NISSAN DIESEL AMERICA, INC.

TECHNICAL BULLETIN FS-09 (Rev. A)

ENGINE LOW POWER DUE TO COLLAPSED OR KINKED CLEAR FUEL HOSES

J05/Light Duty

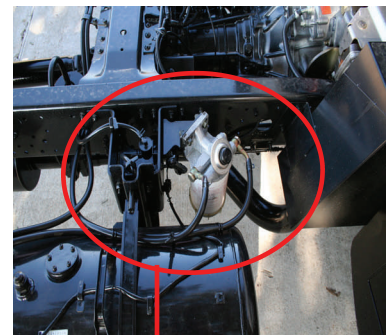
Field investigations have found that the J05 and J08 engine clear suction fuel hoses at the fuel tank and/or the fuel filter/sedimentor may collapse or kink thereby restricting the fuel supply to the engine. J05 engines may also experience a collapse or kink in the fuel return clear hose at the fuel supply pump. See photos for location.

Main areas for kinked or collapsed fuel hoses

Replace the clear plastic hoses from the fuel tank to the inlet fitting of the fuel filter/sedimentor and from the outlet fitting of the fuel filter/sedimentor to the metal fuel tubes with suitable braided reinforced hoses. Use the same reinforced style when replacing the clear fuel return hoses.

J08/Medium Duty

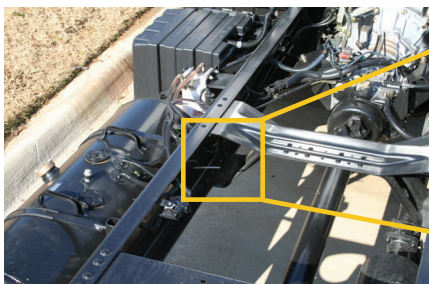
Even though the hose appears to be in good condition it has been reported that the hoses can still collapse under full fuel load conditions.

3rd Crossmember

Driver's side frame (LH side rail)
